CONCEPTUAL DRAINAGE PLAN
The following items concerning the Brake Masters San Antonio Drainage Plan are contained hereon:

DRAINAGE CERTIFICATION

GRADING AND DRAINAGE PLAN BRAKE MASTERS - SAN ANTONIO WYOMING COMMERCIAL COMPLEX

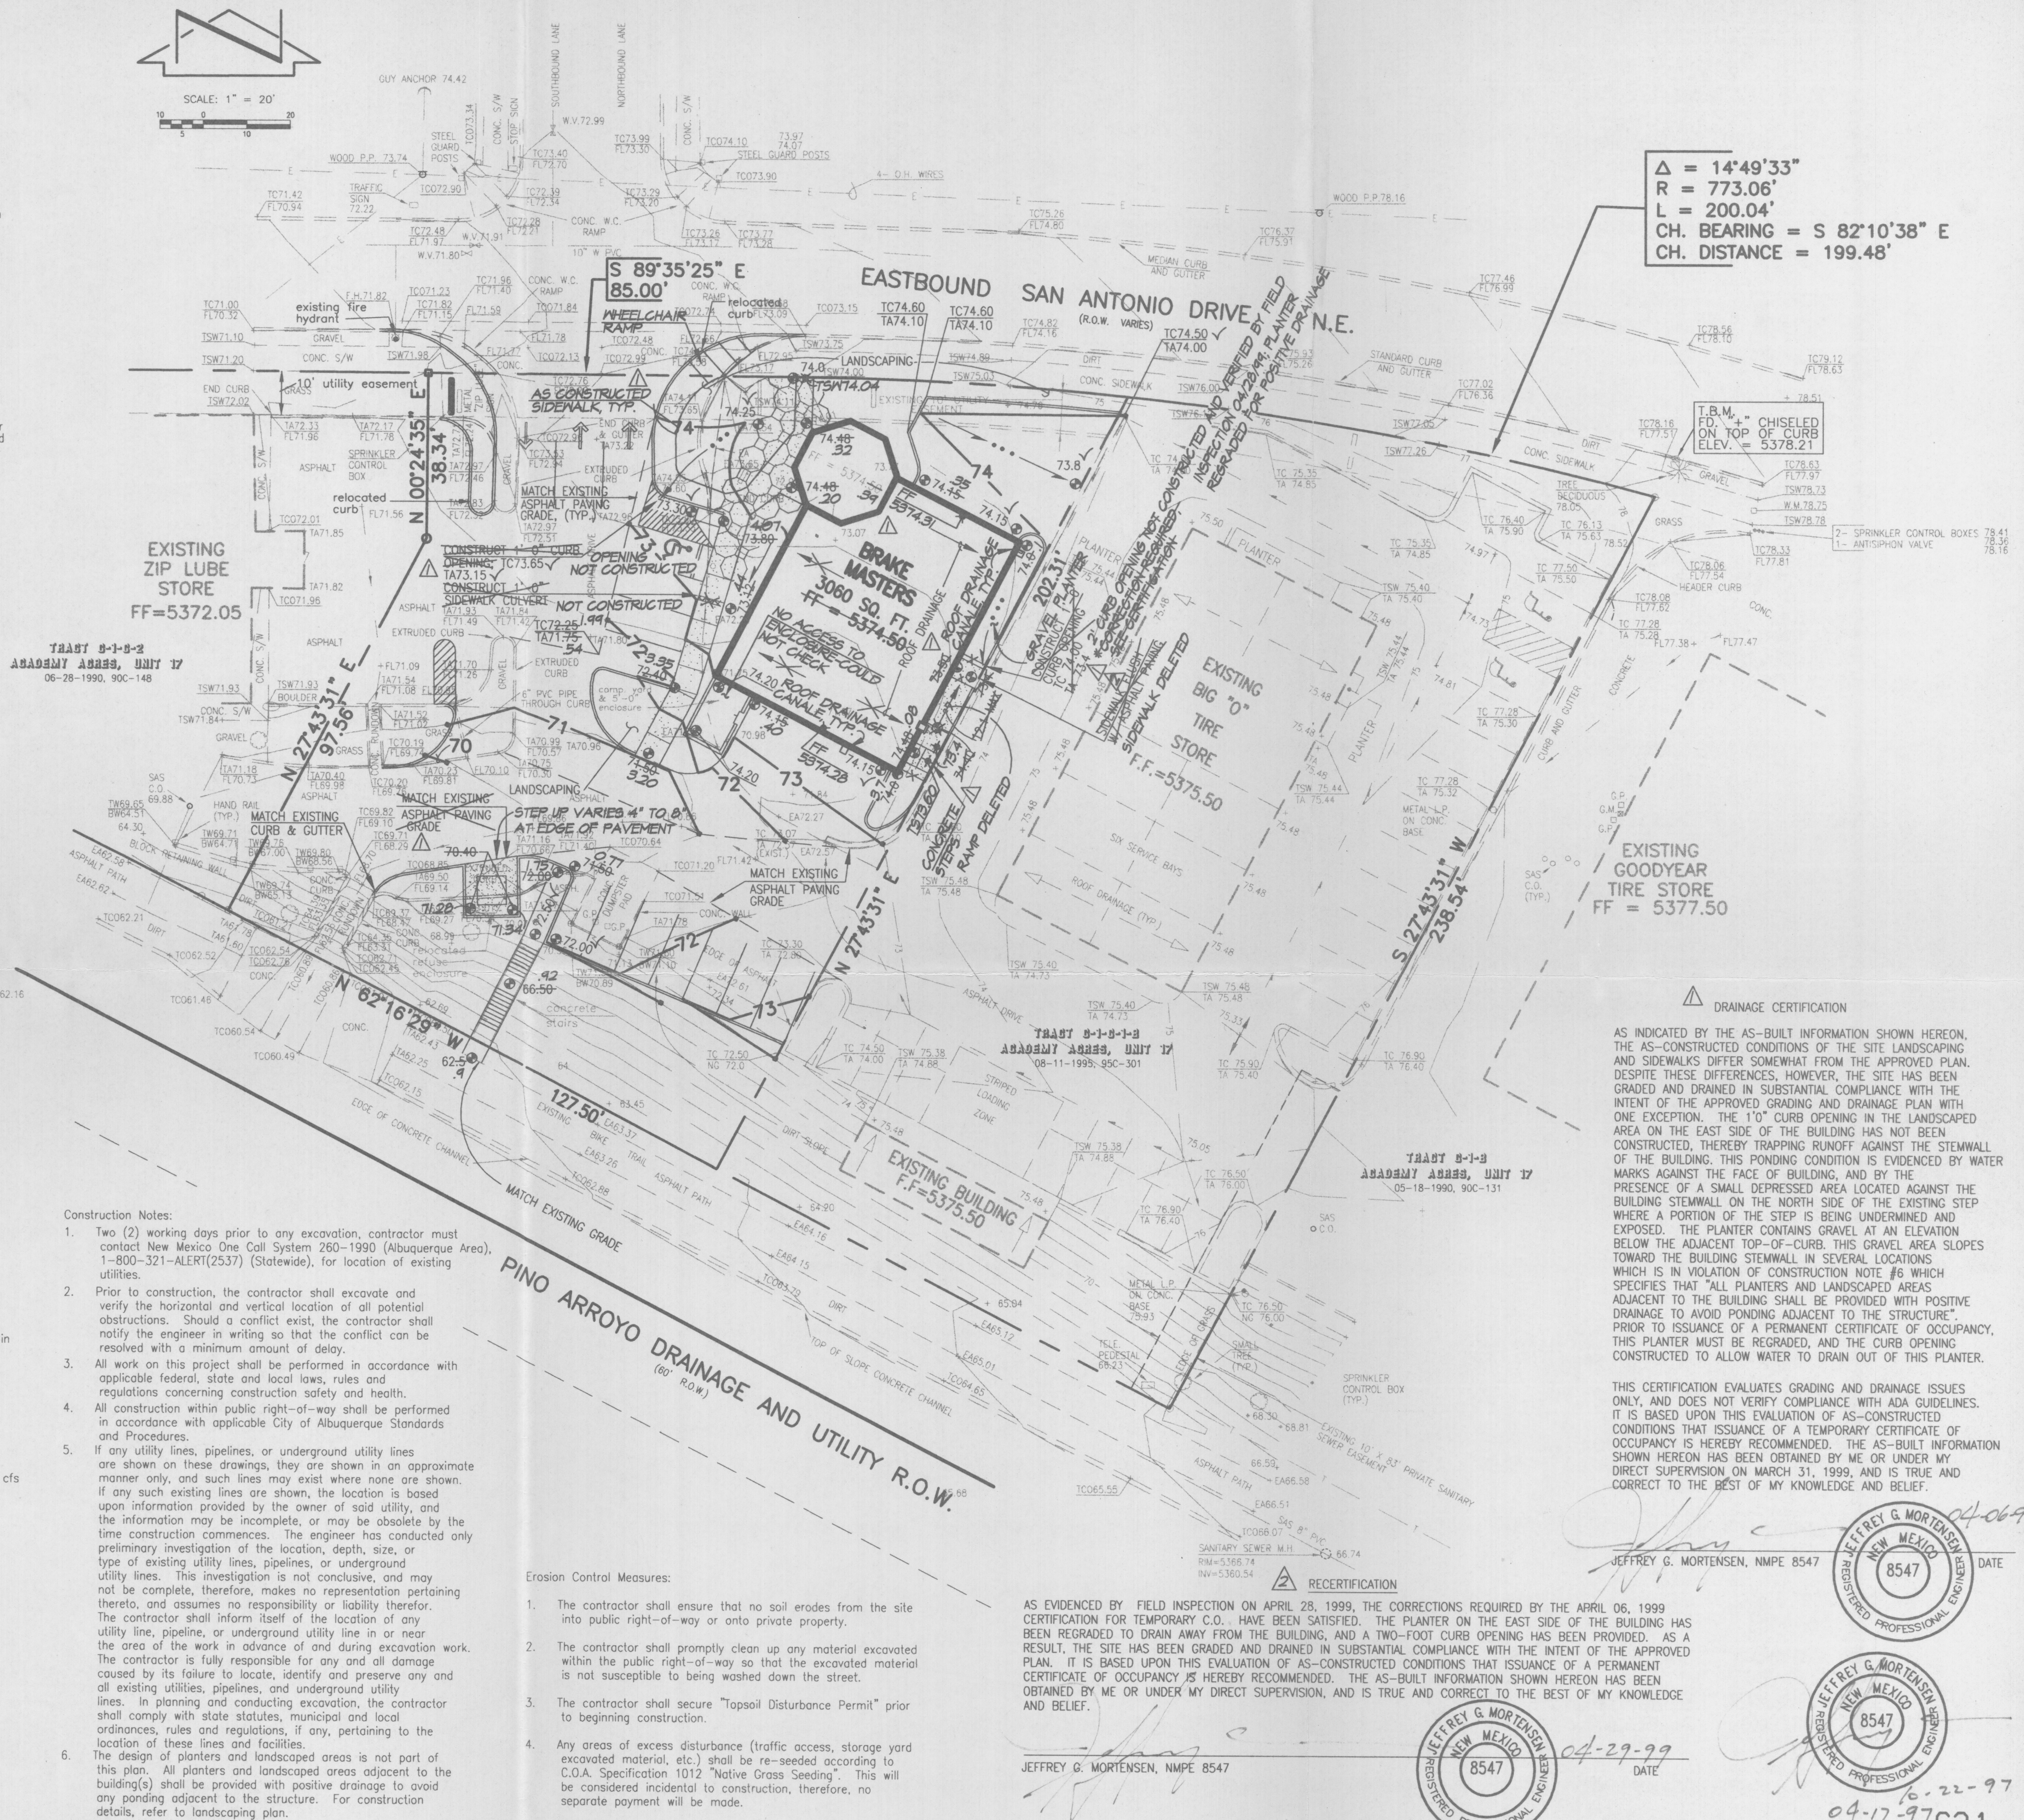
AS INDICATED BY THE AS-BUILT INFORMATION SHOWN HEREON, THE AS-CONSTRUCTED CONDITIONS OF THE SITE LANDSCAPING AND SIDEWALKS DIFFER SOMEWHAT FROM THE APPROVED PLAN. DESPITE THESE DIFFERENCES, HOWEVER, THE SITE HAS BEEN GRADED AND DRAINED IN SUBSTANTIAL COMPLIANCE WITH THE INTENT OF THE APPROVED GRADING AND DRAINAGE PLAN WITH ONE EXCEPTION. THE 10" CURB OPENING IN THE LANDSCAPED AREA ON THE EAST SIDE OF THE BUILDING HAS NOT BEEN CONSTRUCTED, THEREBY TRAPPING RUNOFF AGAINST THE STEMMALL OF THE BUILDING. THIS PONDING CONDITION IS EVIDENCED BY WATER MARKS AGAINST THE FACE OF BUILDING, AND BY THE PRESENCE OF A SMALL DEPRESSED AREA LOCATED AGAINST THE BUILDING STEMMALL ON THE NORTH SIDE OF THE EXISTING STEP WHERE A PORTION OF THE STEP IS BEING UNDERMINED AND EXPOSED. THE PLANTER CONTAINS GRAVEL AT AN ELEVATION BELOW THE ADJACENT TOP-OF-CURB. THIS GRAVEL AREA SLOPES TOWARD THE BUILDING STEMMALL IN SEVERAL LOCATIONS WHICH IS IN VIOLATION OF CONSTRUCTION NOTE #6 WHICH SPECIFIES THAT "ALL PLANTERS AND LANDSCAPED AREAS ADJACENT TO THE BUILDING SHALL BE PROVIDED WITH POSITIVE DRAINAGE TO AVOID PONDING ADJACENT TO THE STRUCTURE". PRIOR TO ISSUANCE OF A PERMANENT CERTIFICATE OF OCCUPANCY, THIS PLANTER MUST BE REGRADED, AND THE CURB OPENING CONSTRUCTED TO ALLOW WATER TO DRAIN OUT OF THIS PLANTER.

AS EVIDENCED BY FIELD INSPECTION ON APRIL 28, 1999, THE CORRECTIONS REQUIRED BY THE APRIL 06, 1999 CERTIFICATION FOR TEMPORARY C.O. HAVE BEEN SATISFIED. THE PLANTER ON THE EAST SIDE OF THE BUILDING HAS BEEN REGRADED TO DRAIN AWAY FROM THE BUILDING, AND A TWO-FOOT CURB OPENING HAS BEEN PROVIDED. AS A RESULT, THE SITE HAS BEEN GRADED AND DRAINED IN SUBSTANTIAL COMPLIANCE WITH THE INTENT OF THE APPROVED PLAN. IT IS BASED UPON THIS EVALUATION OF AS-CONSTRUCTED CONDITIONS THAT ISSUANCE OF A PERMANENT CERTIFICATE OF OCCUPANCY IS HEREBY RECOMMENDED. THE AS-BUILT INFORMATION SHOWN HEREON HAS BEEN OBTAINED BY ME OR UNDER MY DIRECT SUPERVISION, AND IS TRUE AND CORRECT TO THE BEST OF MY KNOWLEDGE AND BELIEF.
